Former ASARCO East Helena Facility Interim Measures Work Plan—2014

Prepared for
The Montana Environmental Trust Group, LLC
Trustee of the Montana Environmental Custodial Trust

May 2014

FIGURE 3-4
Arsenic Contamination in Soil –
Surface to Top of Tertiary
Ash/Clay Layer
Interim Measures Work Plan-2014
East Helena, Montana

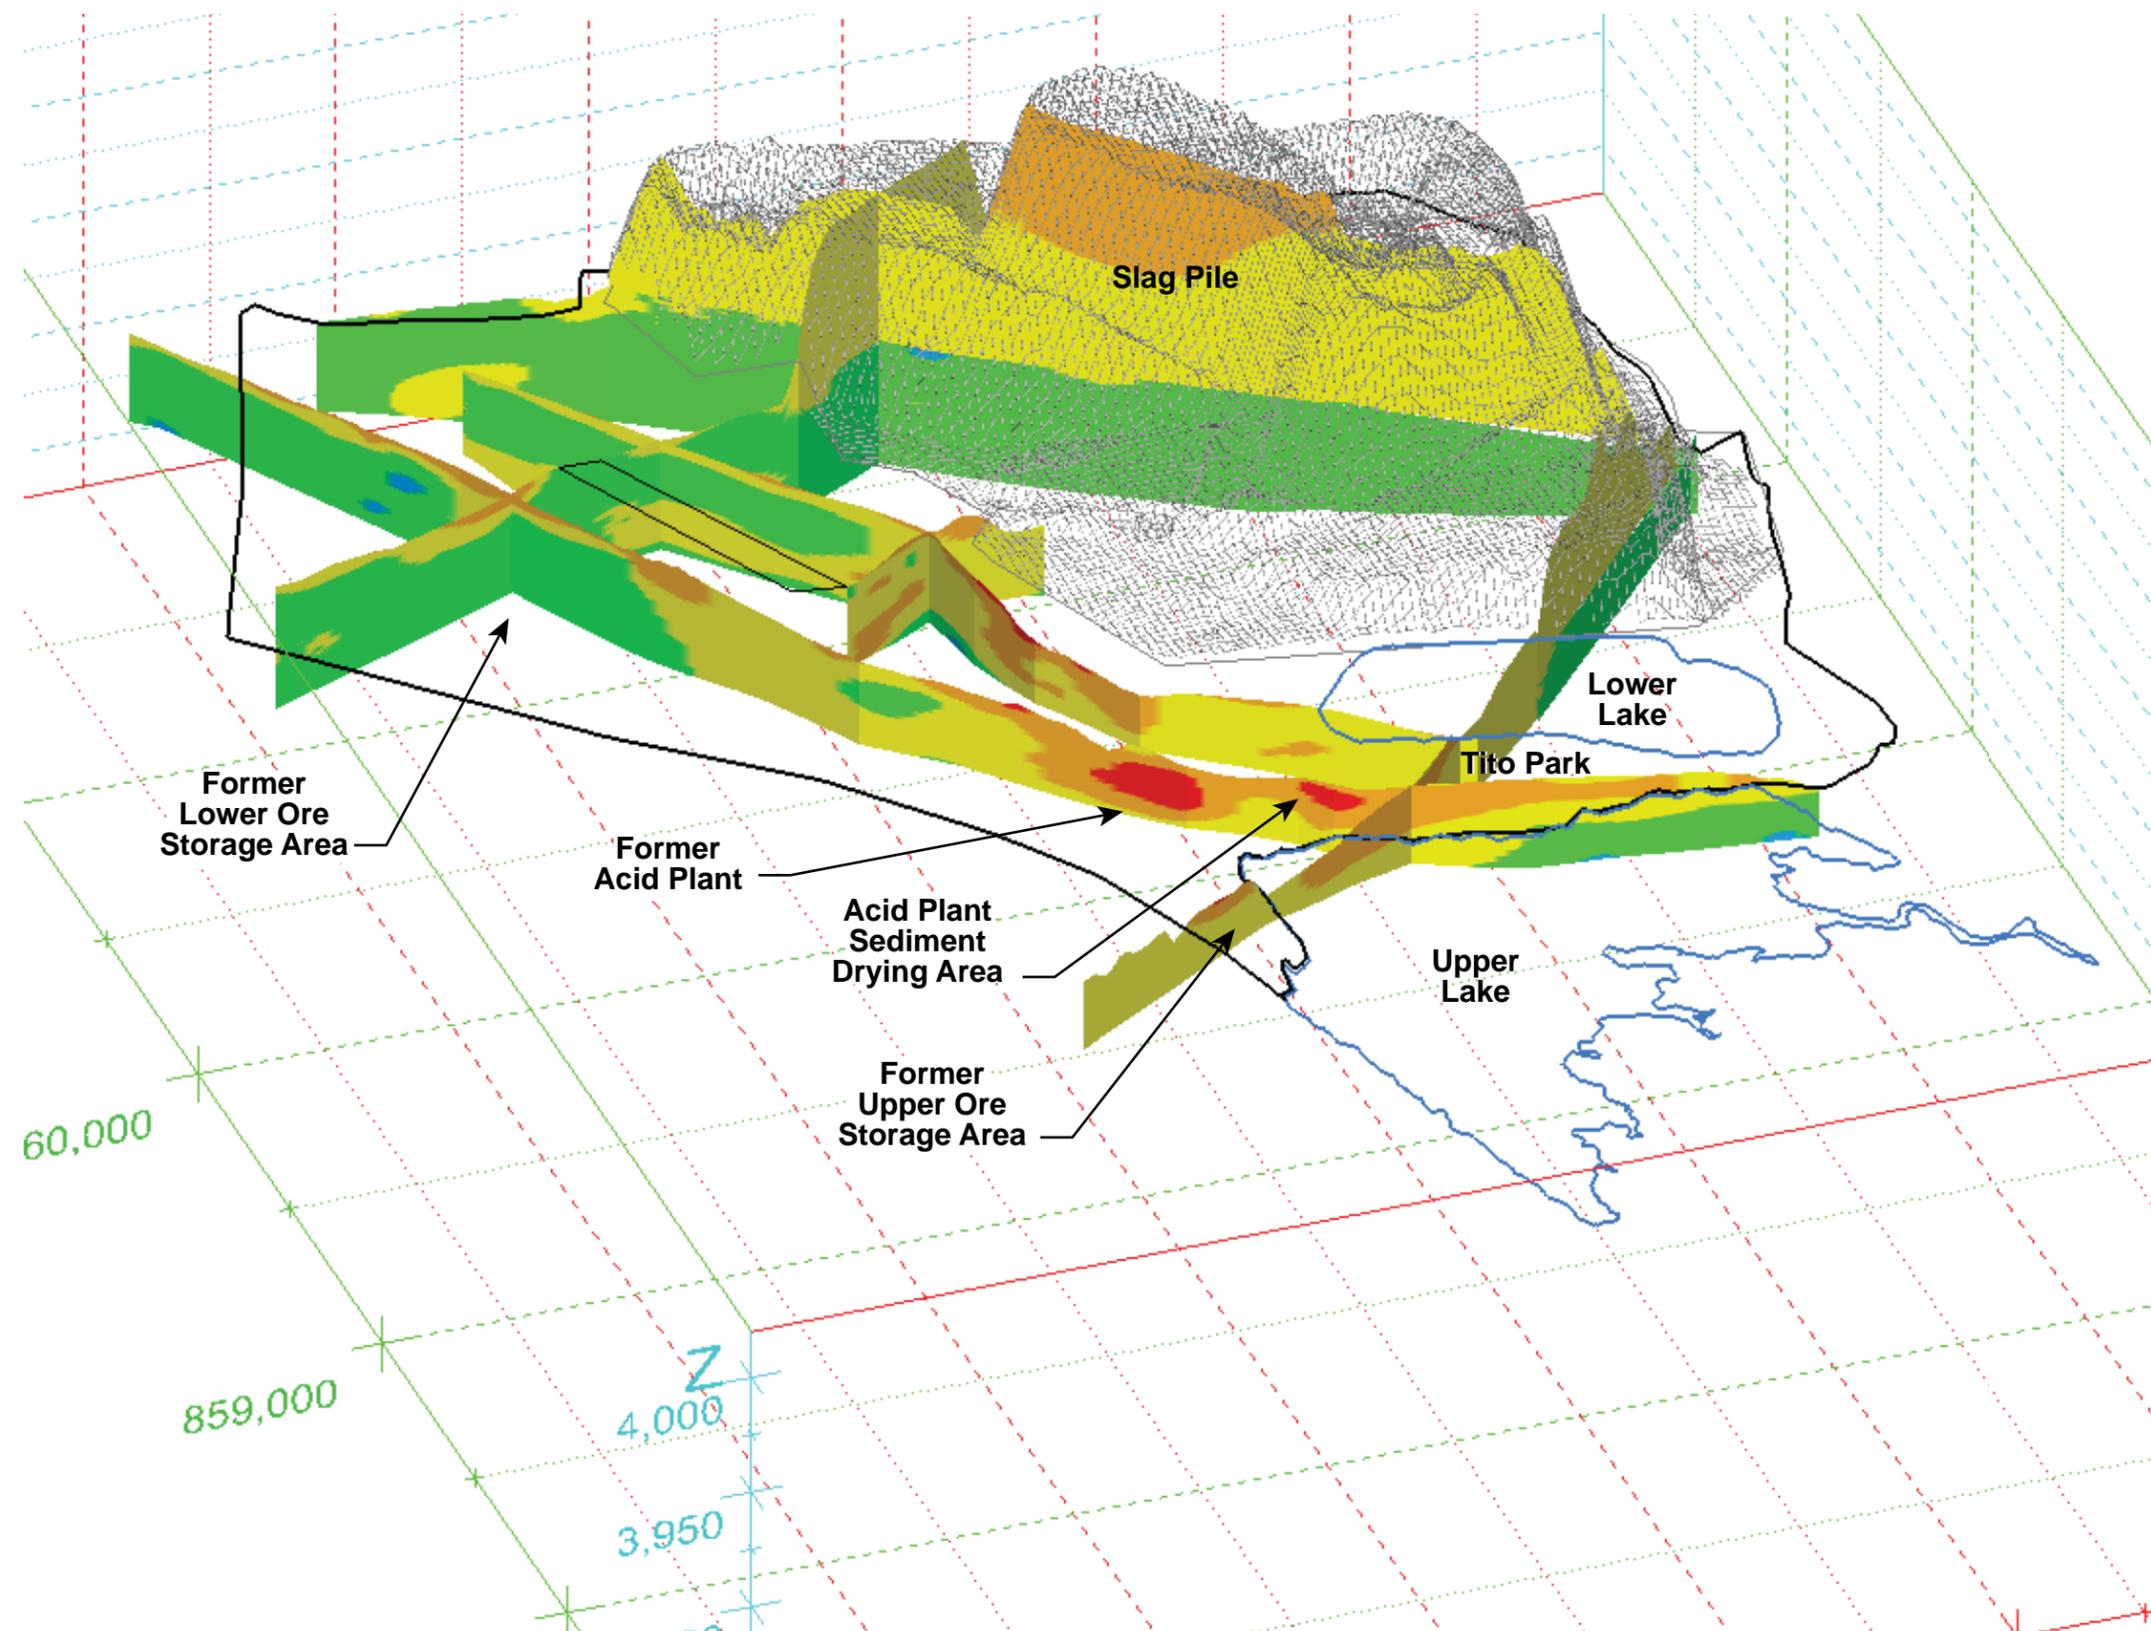
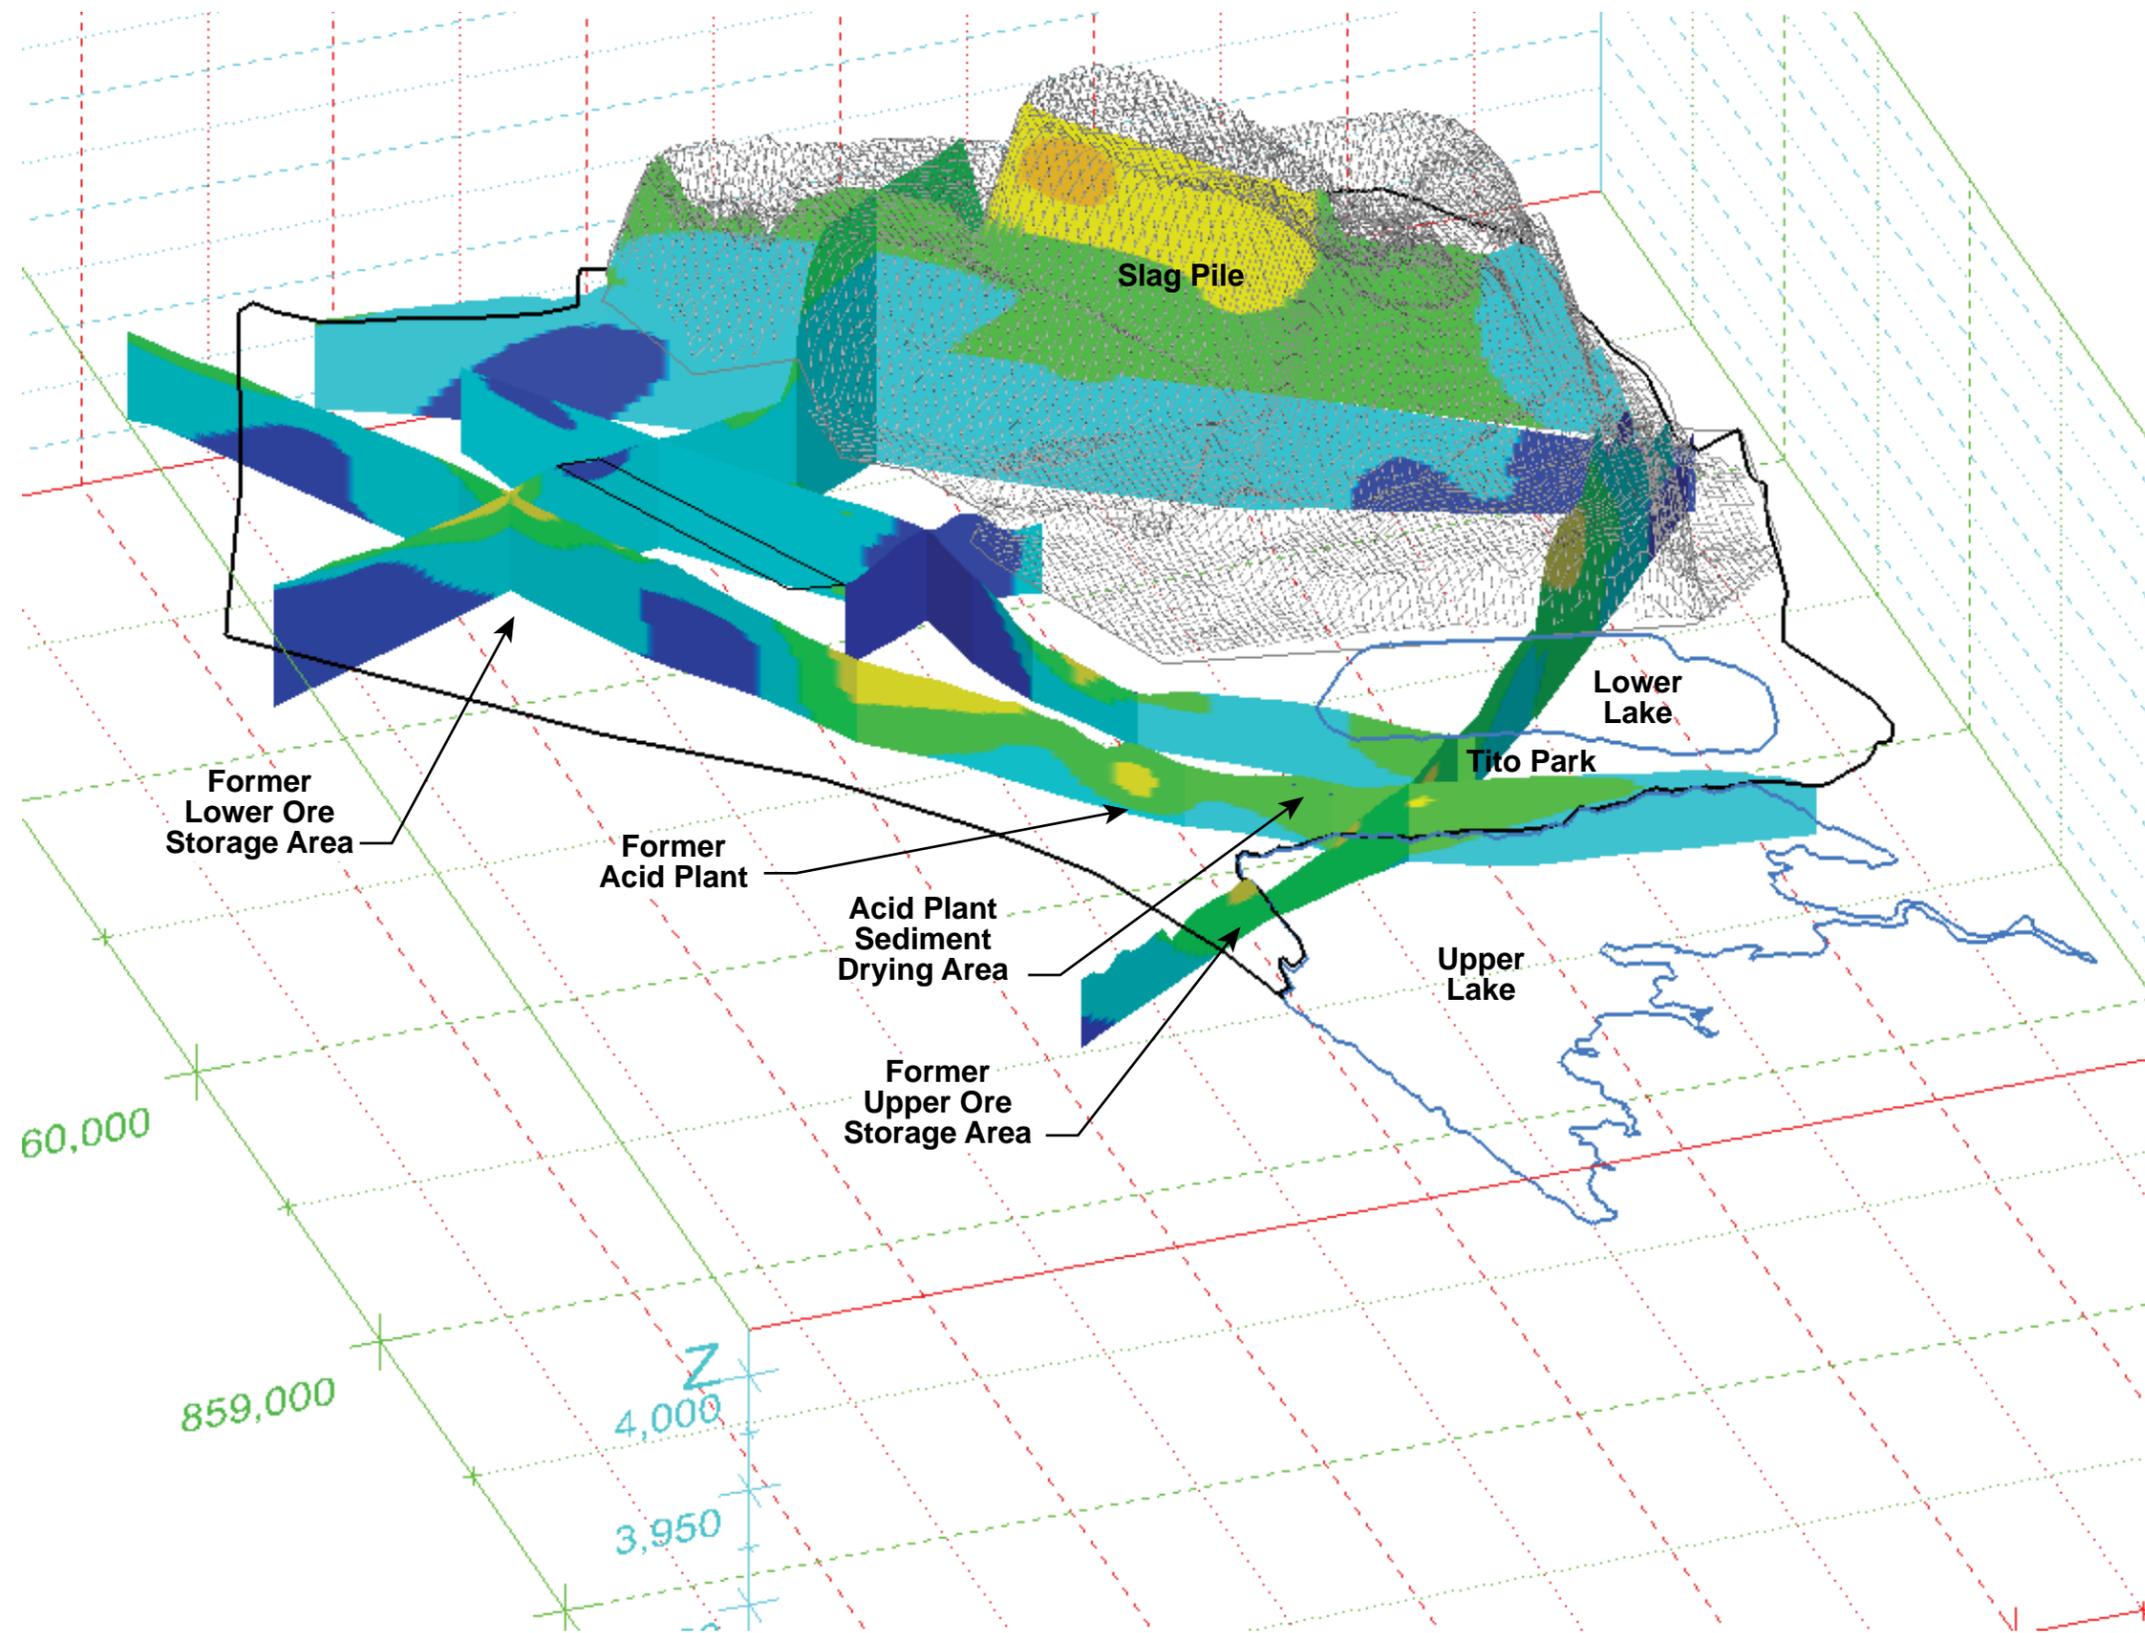
Figures 3.4 and 3.5, p. 3-10 and 3-11. The cross section figures depicting contamination should also include criteria outlined in the previous comment for Figures 3.2 and 3.3. In addition, the location of the water table across the site should be added to the cross sections for clarity to help understand the distribution of the source area soils in the subsurface.

FIGURE 3-6
Dissolved Arsenic Concentrations in Groundwater—June 2013
 Interim Measures Work Plan—2014
 East Helena, Montana

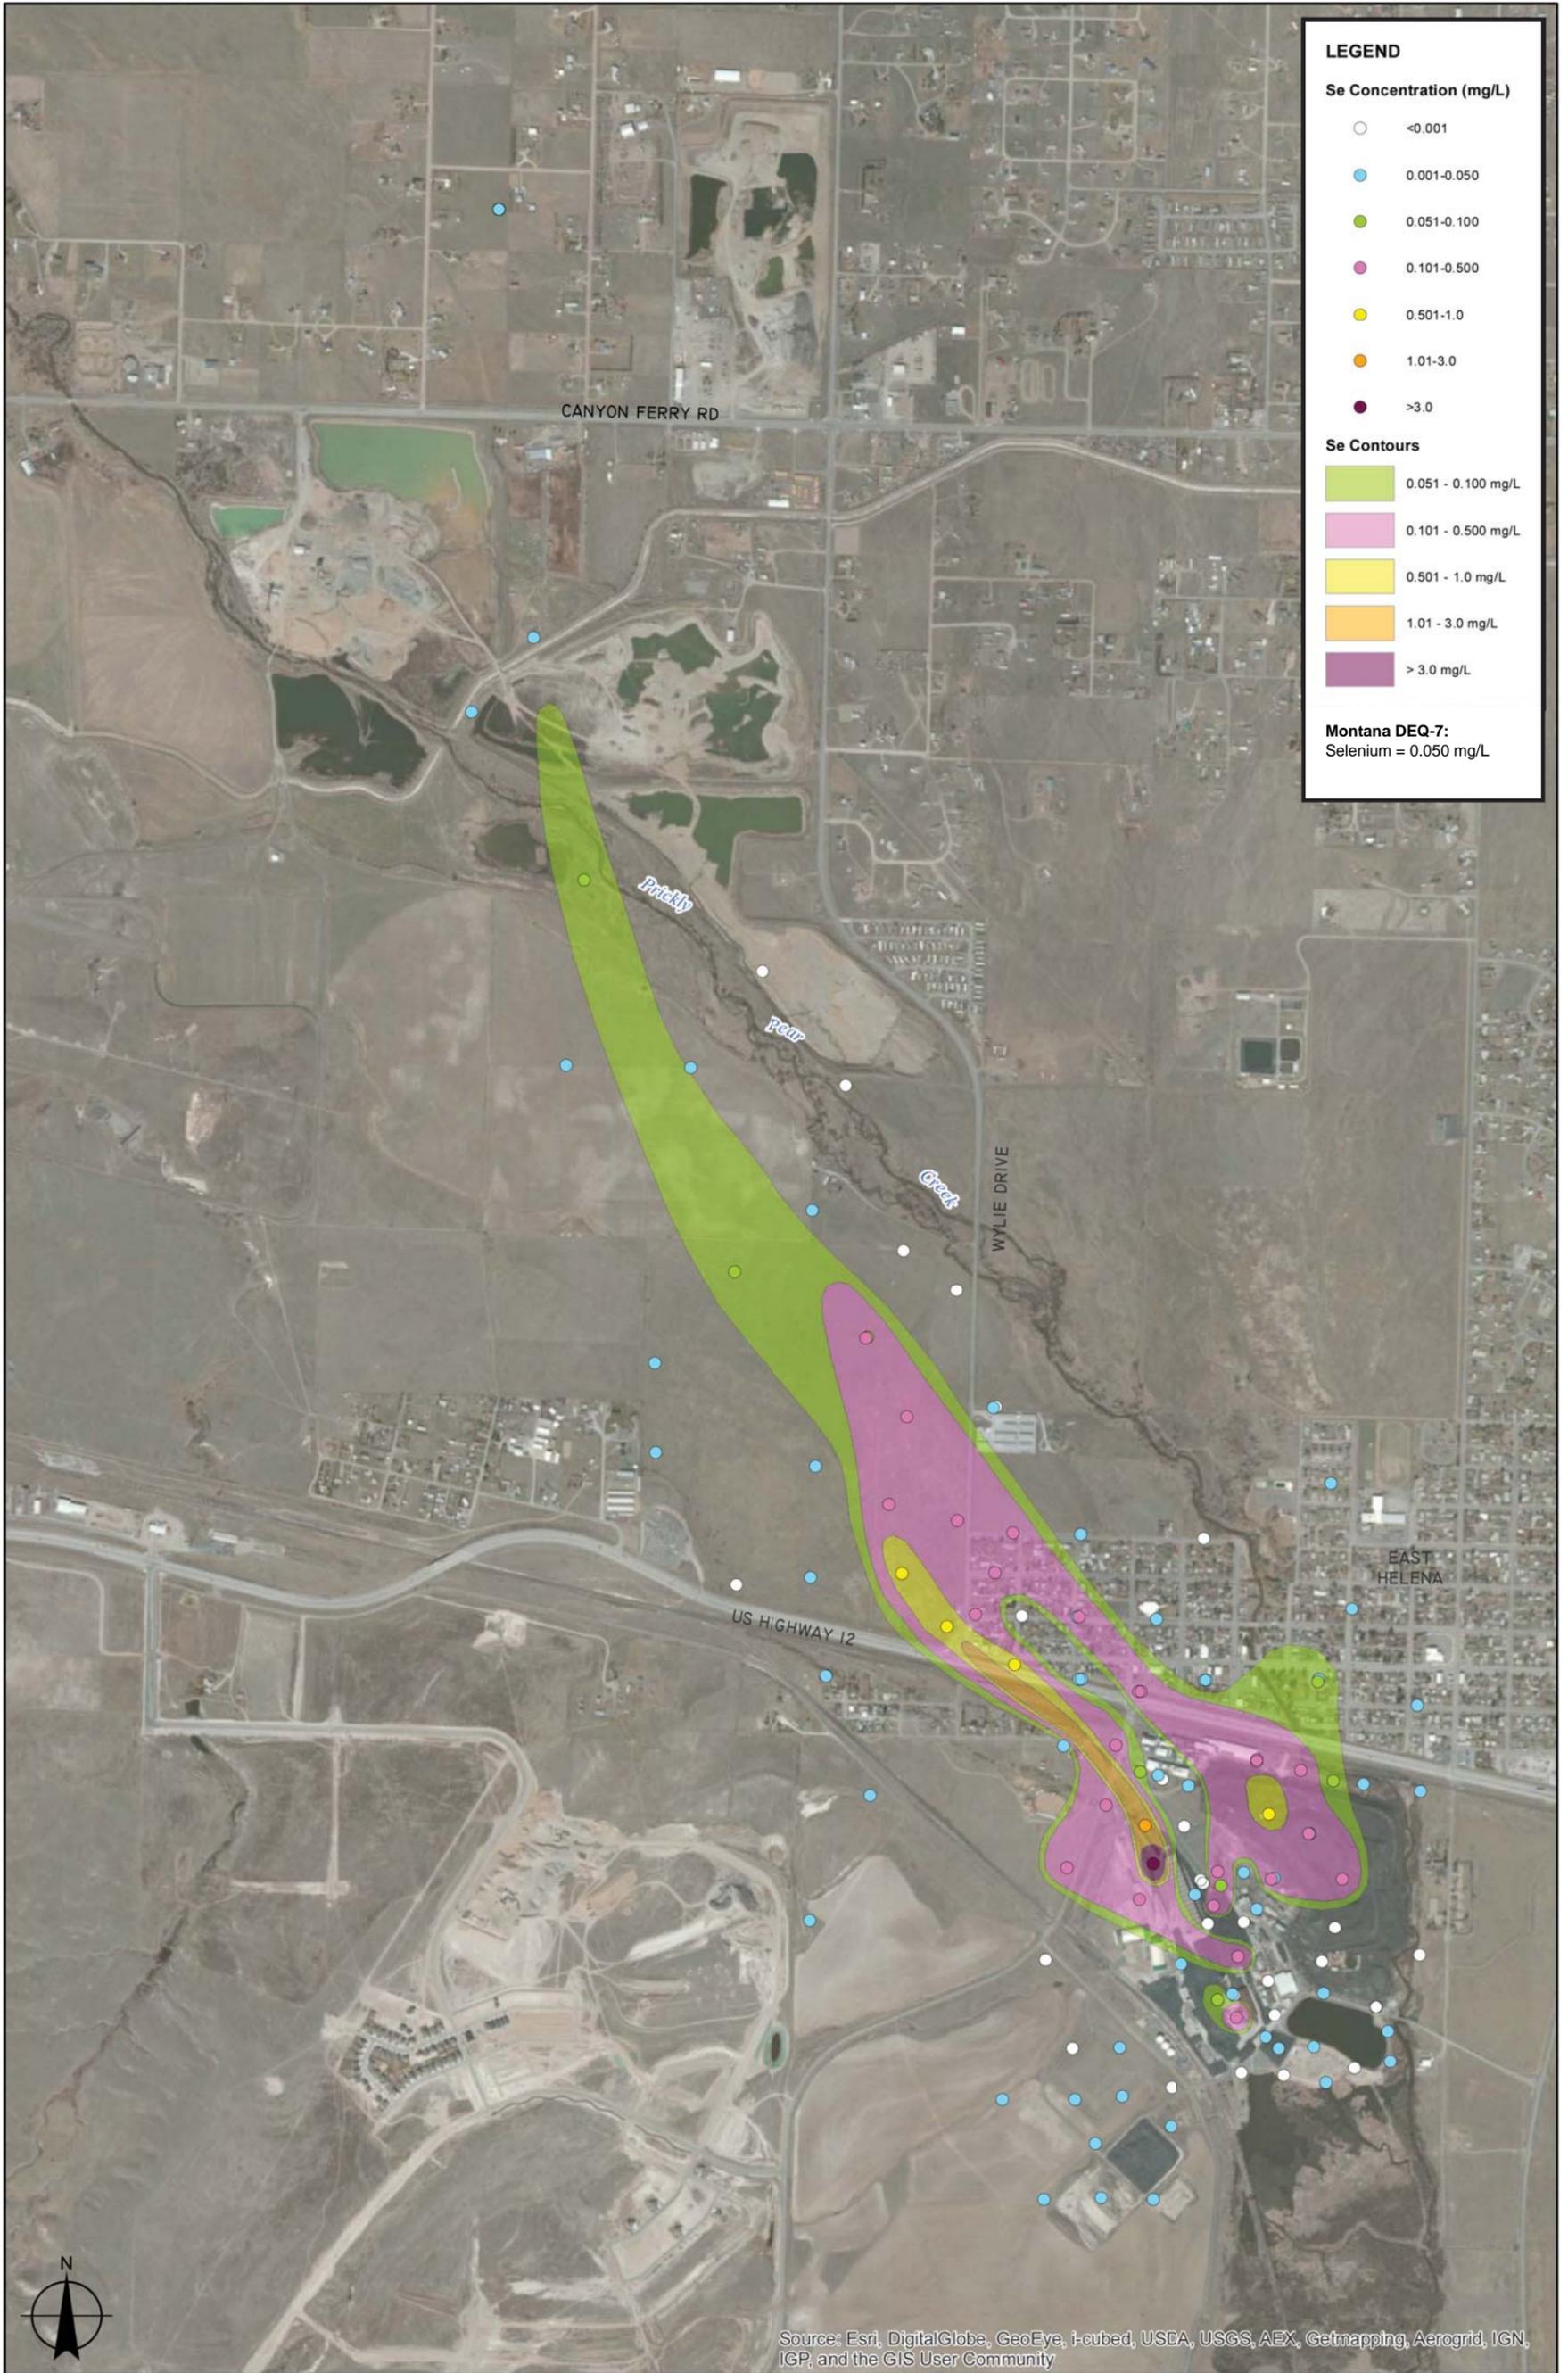
Figure 3.6, p. 3-12. The area west of the site with elevated ground water arsenic levels should be identified as reflecting background conditions, and not linked to site activities. While Wilson Ditch brought arsenic laden waters to the area east of Seaver Park and Lamping Field, the Seaver Park Residential area and other areas within the Tertiary bench are upgradient from the site. This is an important distinction, especially for the non-technical public.

EPA Response – EPA agrees with this comment and a note to this effect will be added to Figure 3.6.
